H11862

OPR-G347-NRT2-08

**HYDROGRAPHIC SURVEY
H11862**

B. DATA ACQUISITION AND PROCESSING *See also the Evaluation Report*

1.1) AWOIS 9895 - Delete subm pipe

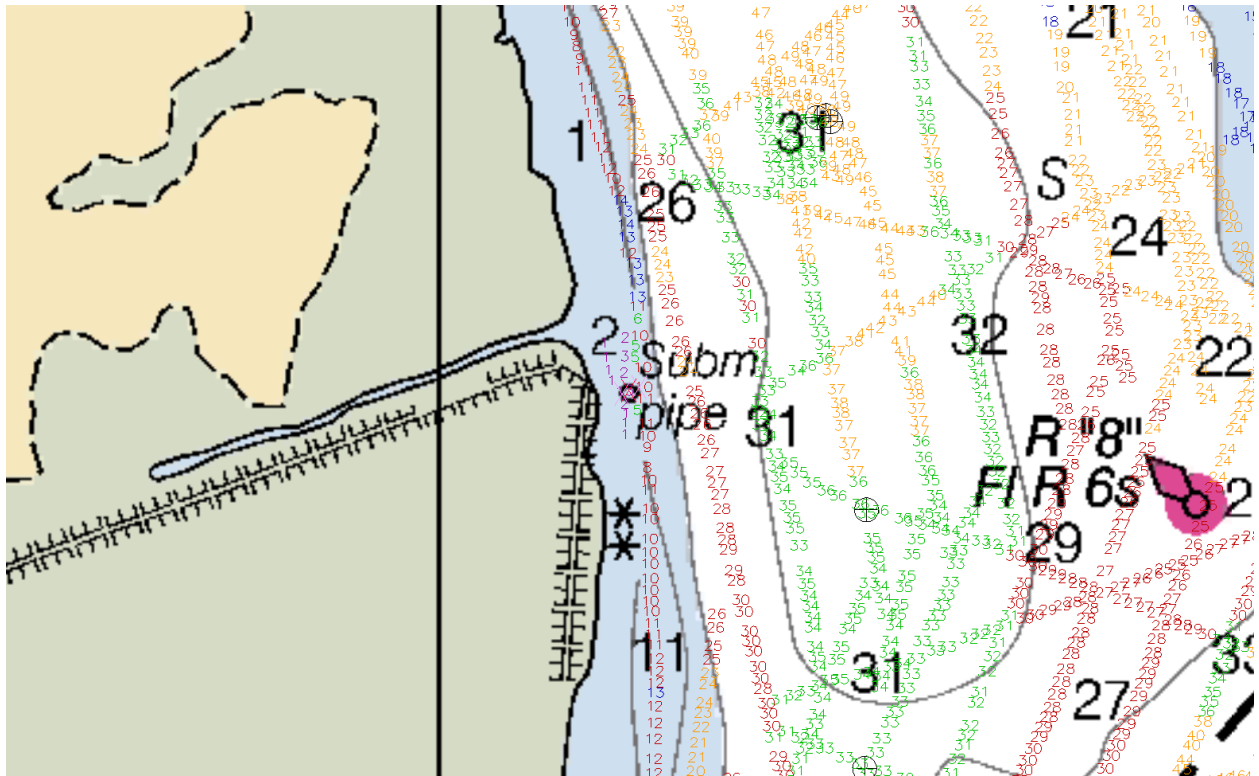
AWOIS ITEM 9895 HISTORY H9409/73-76--NOS FIELD PARTY; LOCATED PIPE BARING 1-FOOT AT MLW IN LAT. 32/50/19.4, LONG. 079/53/53.9 (NAD83). (ENTERED 2/97 BY MBH) H10784/98--OPR-G301-AHP; OBSTRUCTION FOUND AS A 12-INCH DIAMETER PIPE EXPOSED 0.5 METER (1.6 FEET) AT MLLW IN LAT. 32/50/19.73N, LONG. 079/53/53.50W (NAD83). (UPDATED 4/99 BY MBH) OPR-G347-NRT2-08 // H-11862,2009: LD in common area. Small contact investigated, with no desenable results. Proximity to shore and depths less than 3ft throughout would be of more concern. Recommendation: Remove charted Subm Pipe.RWR

Remove charted subm pipe.

Concur. Based upon the insignificant height above the river bottom, it is recommended to chart shoaler depths in the common area. Recommend to delete the Subm pipe from the chart and ENC. Update area with present survey depths.

1.2) AWOIS 7625

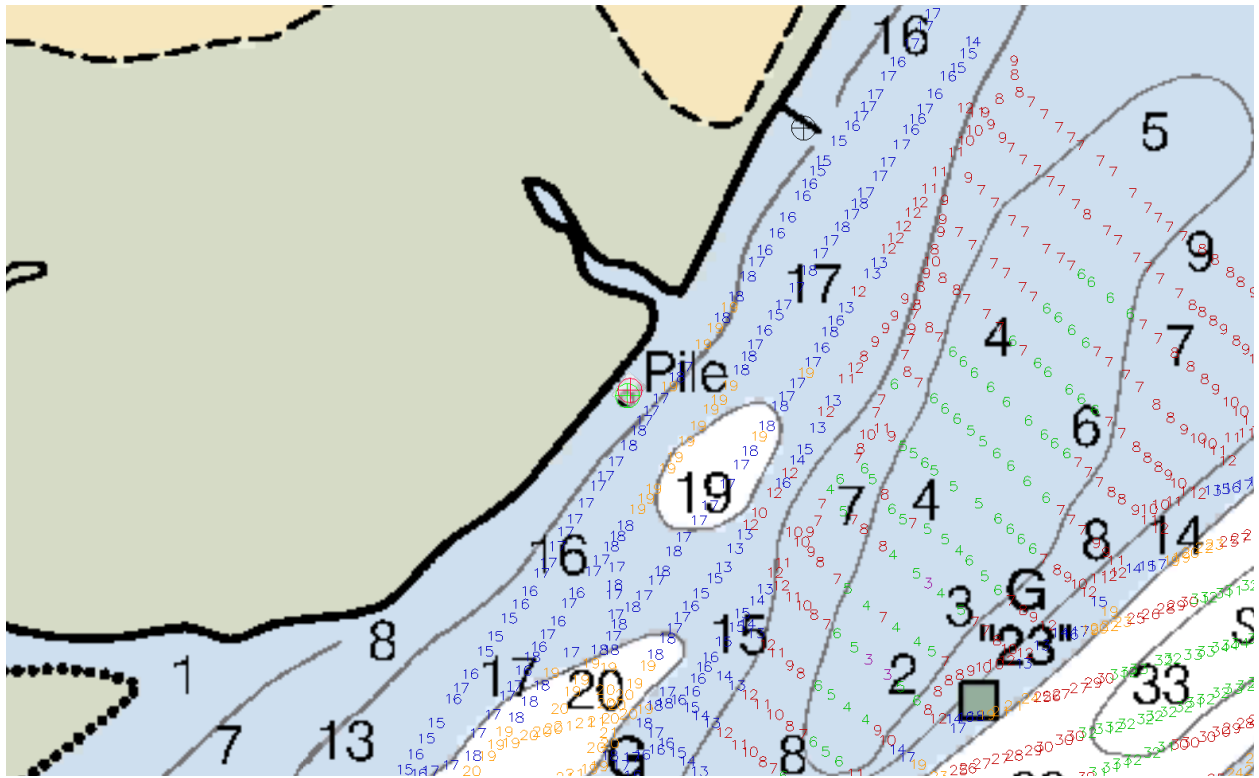
Charted pile located and verified. Retain as charted.

1.3) AWOIS 523 - Remove 3 ft dangerous sunken wreck

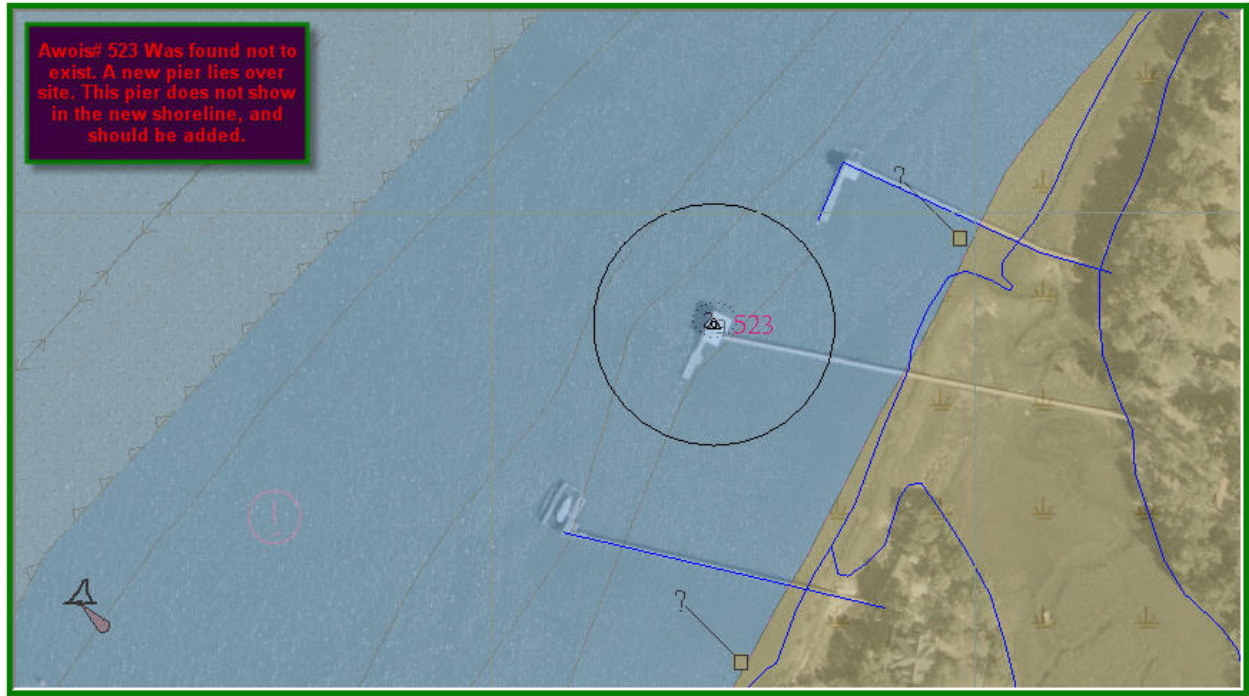
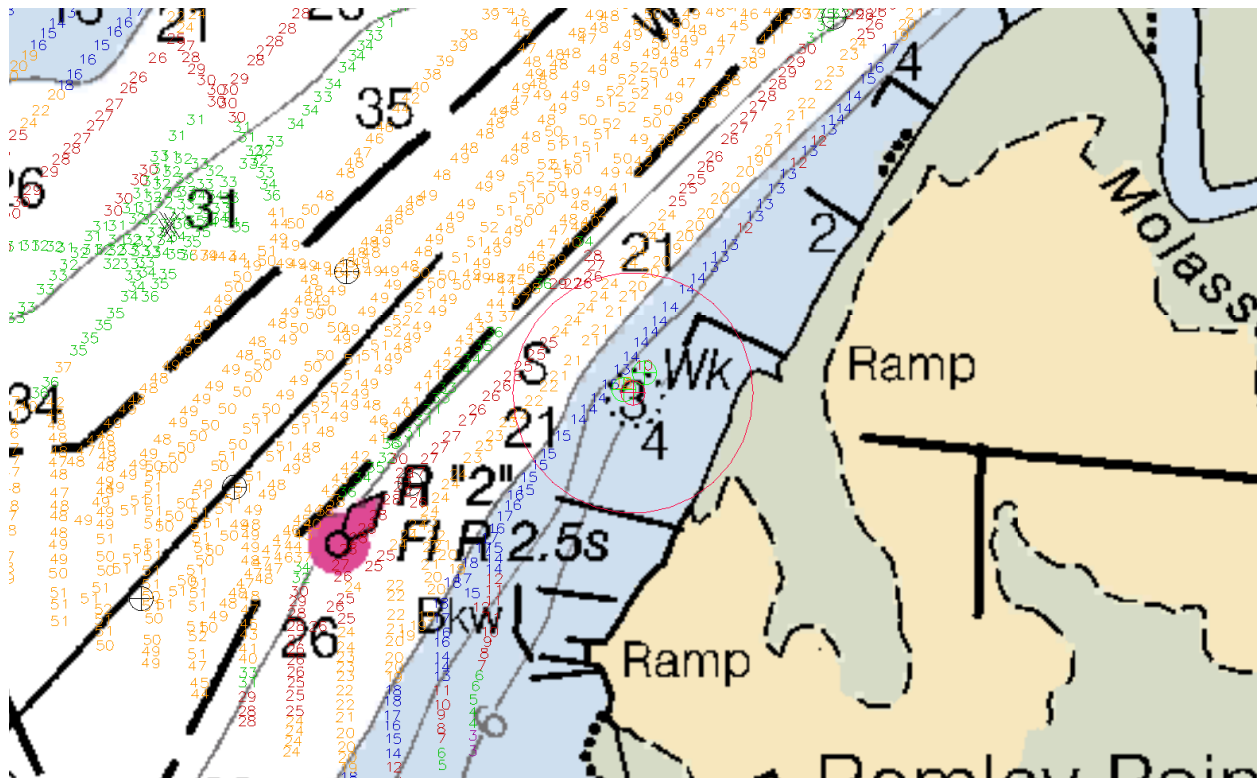
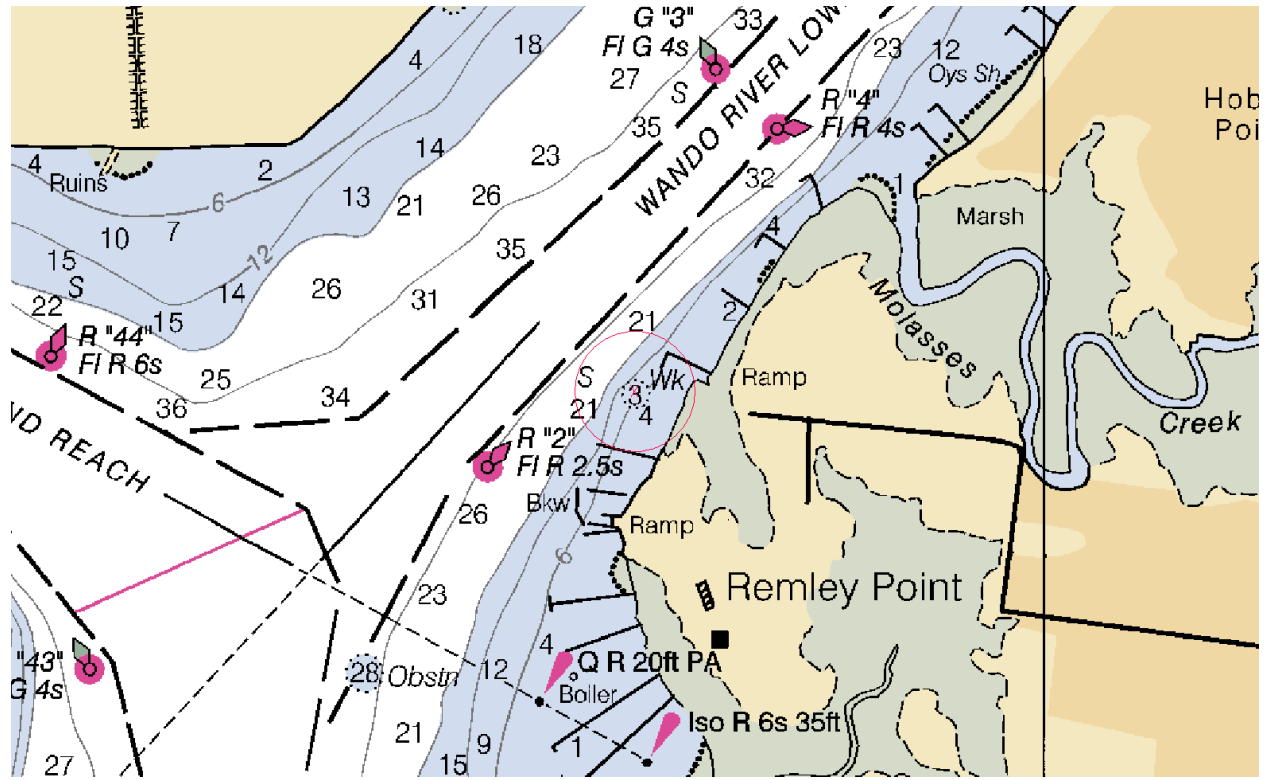
Remove charted WK, and add Pier.

AHB concurs w/ the field. Remove charted 3 ft dangerous sunken wreck. Add pier to chart in vicinity of surveyed location (see orthoimagery). Add white and orange special purpose buoy (Defer to MCD for charting). See USGS High Resolution Orthoimagery for the Charleston, South Carolina Urban Area, 2007 for pier.

1.4) Awois# 10392 delete charted 12-ft Wk

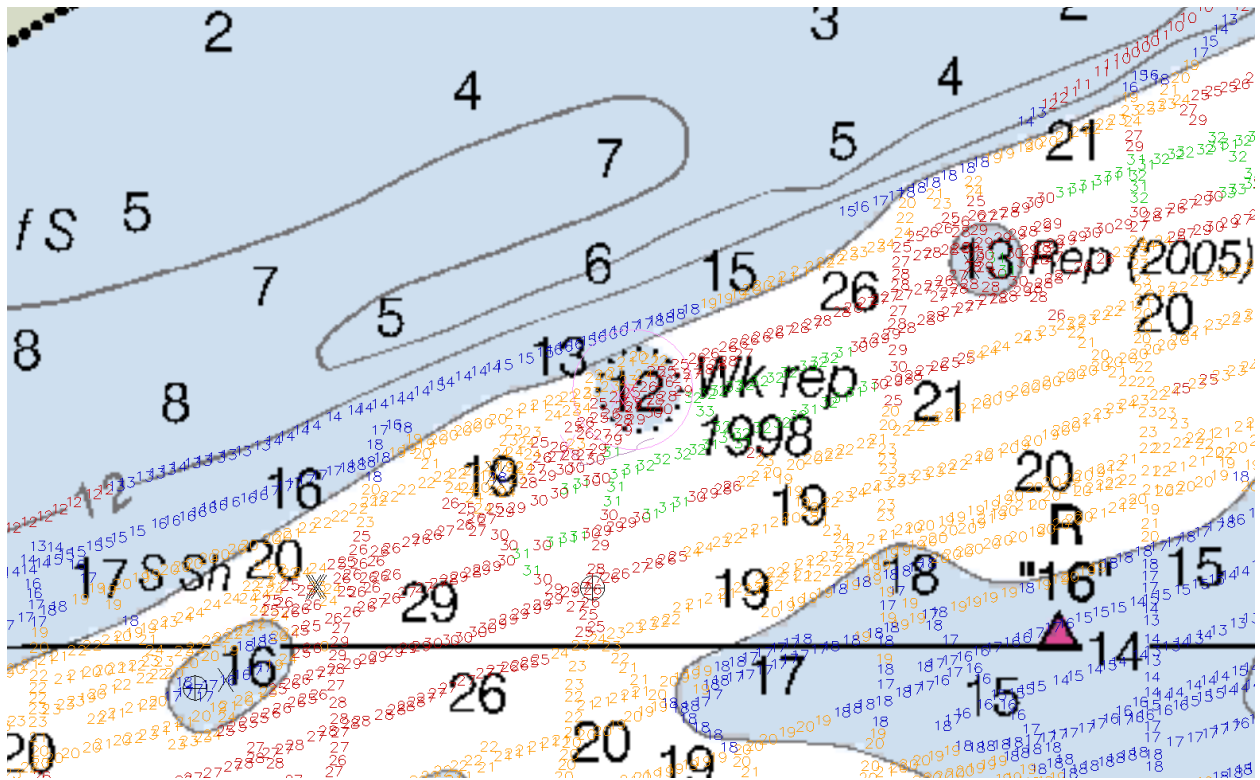
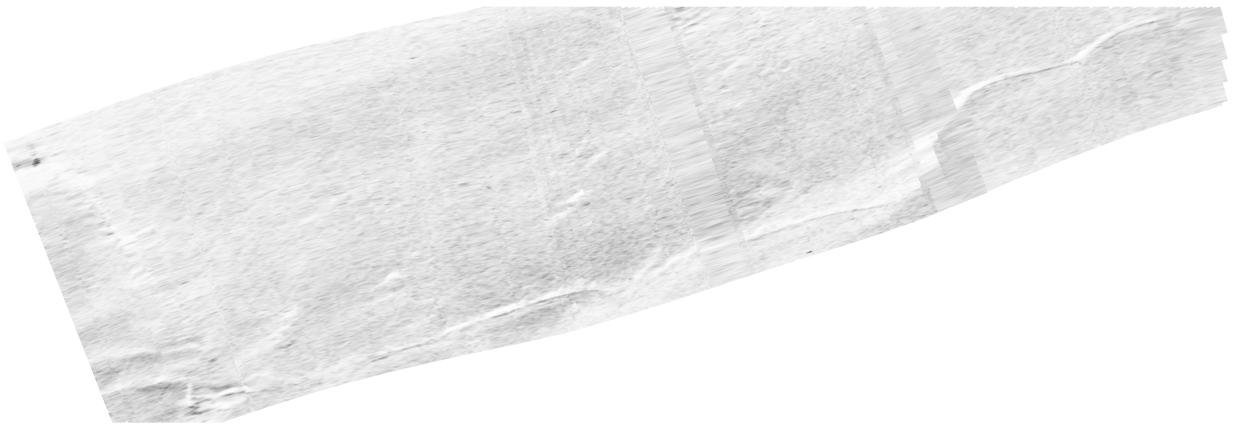
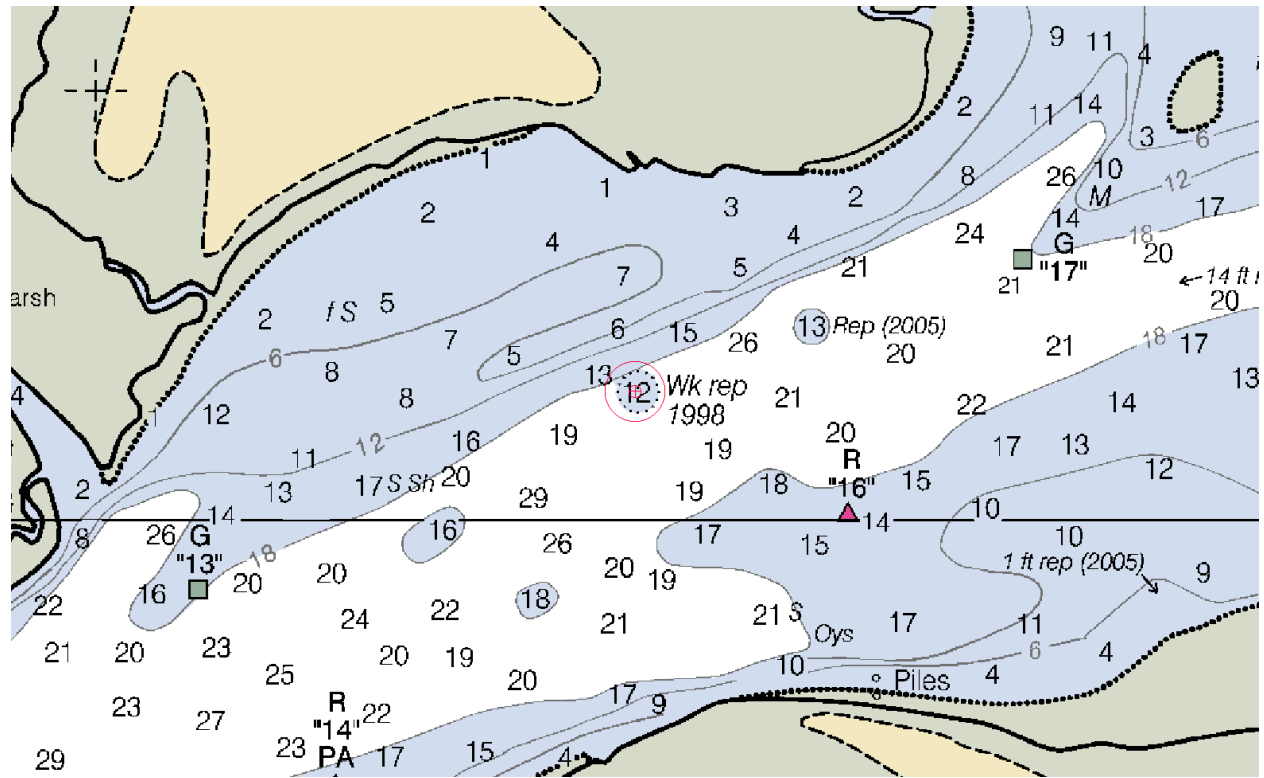
Remove the charted WK and apply survey soundings.

AHB concurs w/ field. 200% SSS shows no sign of charted wreck. AHB recommends deleting charted 12-ft wreck. Chart survey depths within the common area.

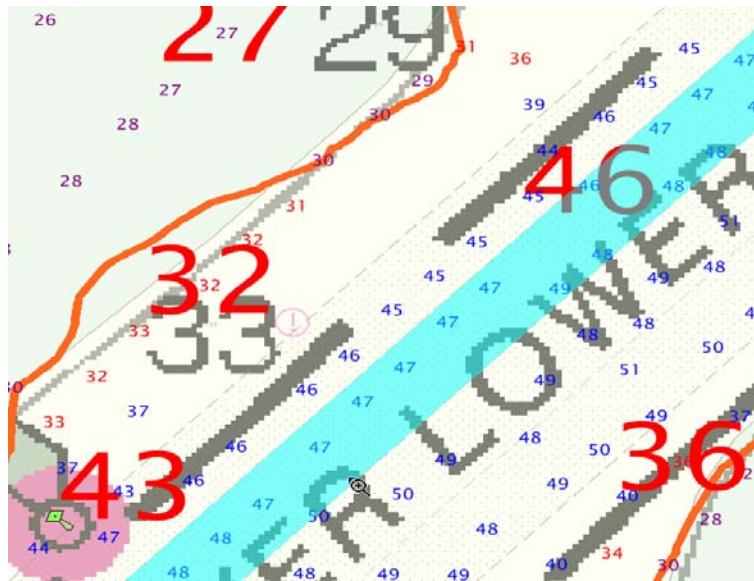
a. Revise the 0 foot contour (low water limits) in the vicinity of Latitude 32°49’ 23.116”N, Longitude 079°53’51.775”W.
